AMENDMENTS TO THE DRAWINGS:

REMARKS

Fig. 4

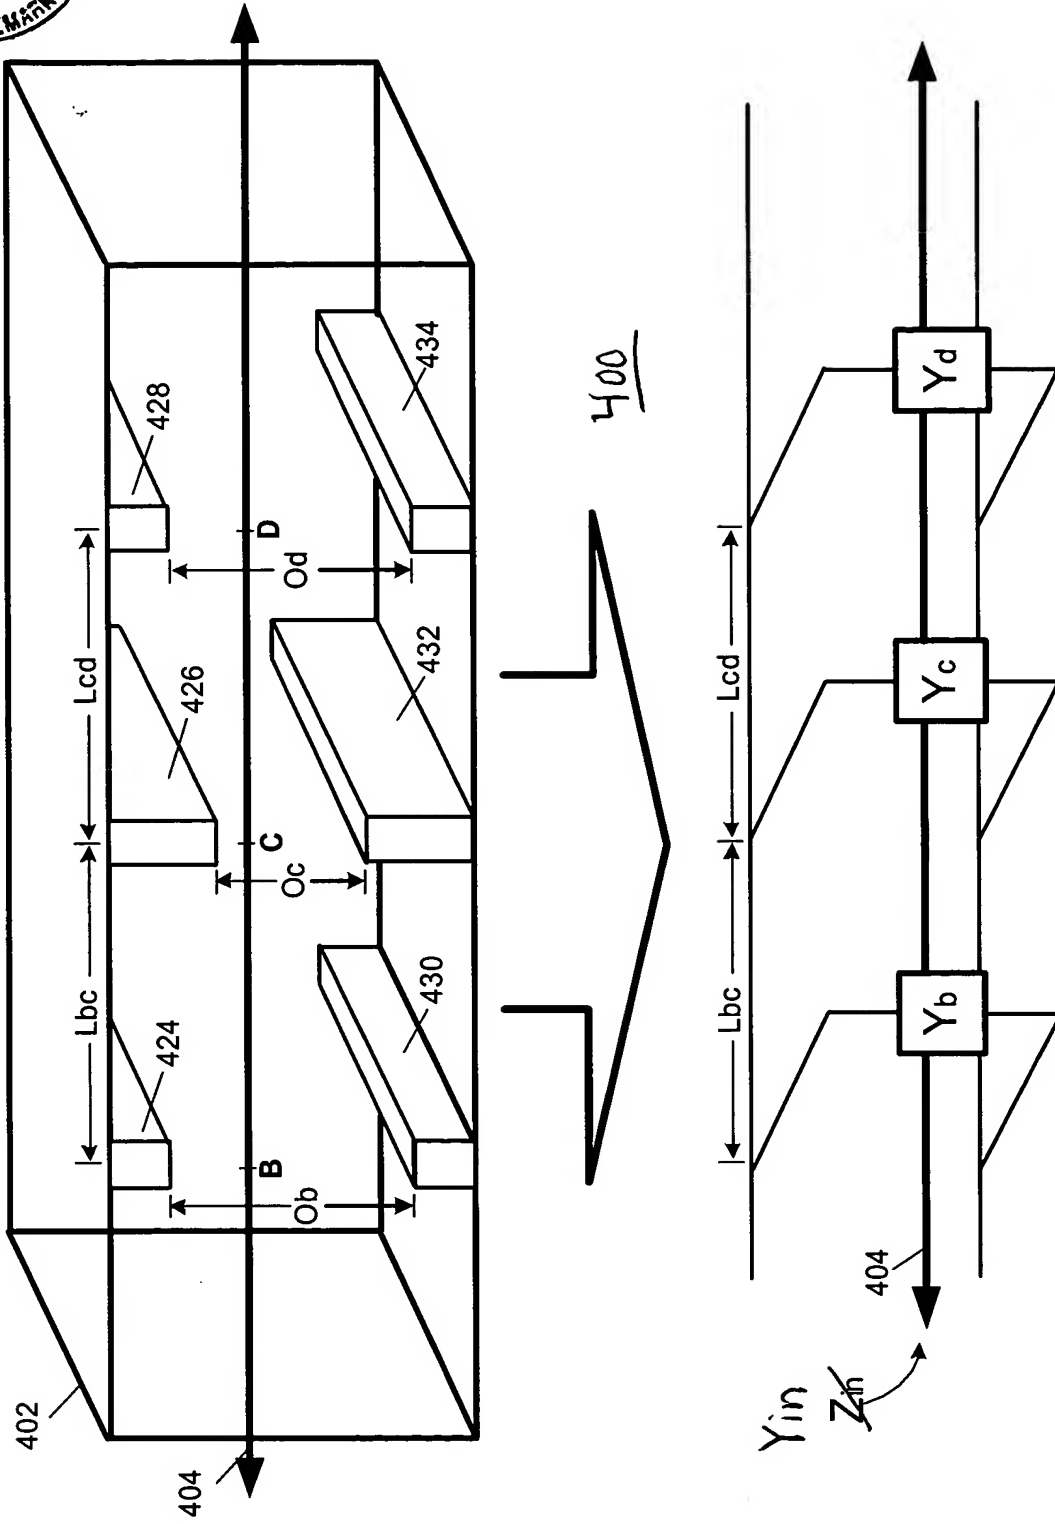
The attached sheets of drawings includes changes to Figs. 1 and 4. These sheets, which include Fig. 1 and Fig. 4, replace the original sheets including Fig. 1 and Fig 4. In Fig. 1, reference item 126 under reference item 110 has been changed to --128-- to correct a typographical error. (See paragraph [0022].) In Fig. 4, the reference character --400-- has been added, as required by the Examiner on page 3 of the Office Action and described in paragraph [0022] of the Office Action. Also in Fig. 4, "Zin" has been replaced by "Yin" because the figure shows admittance along the waveguide path 404, as described in paragraph [0025] of the specification.

On page 3 of the Office Action, the Examiner notes that the reference labels Zin, Yb, Yc, and Yd, as depicted in Fig. 4, are not explicitly described in the specification. In response, paragraph [0025] of the specification has been amended to provide explicit description for the admittances Yb, Yc, and Yd shown in Fig. 4. The present response also includes proposed drawing changes in which the item "Zin," as shown in Fig. 4, has been changed to an admittance "Yin." Support for this change is found in original paragraph [0025], which describes an admittance "Y" along the waveguide path 404.

The Office Action includes an objection to the drawings because Fig. 4 does not show reference labels "400," "Y" and "L." In response, Applicants submit herewith proposed drawing change to Fig. 4 that includes the reference labels "400" and "Yin." As noted above,

Applicants' proposed changes to Fig. 4 include replacing "Zin" with "Yin" and have amended the reference "Y" to "Yin" in the specification because the original specification describes Fig. 4 as showing admittance along the waveguide path 404. Applicants have removed the reference to "L" in the specification because it is believed that the description in paragraph [0025] of separations between openings refers to the exemplary separations "Lbc" and "Lcd" would render redundant such inclusion of an additional label "L."
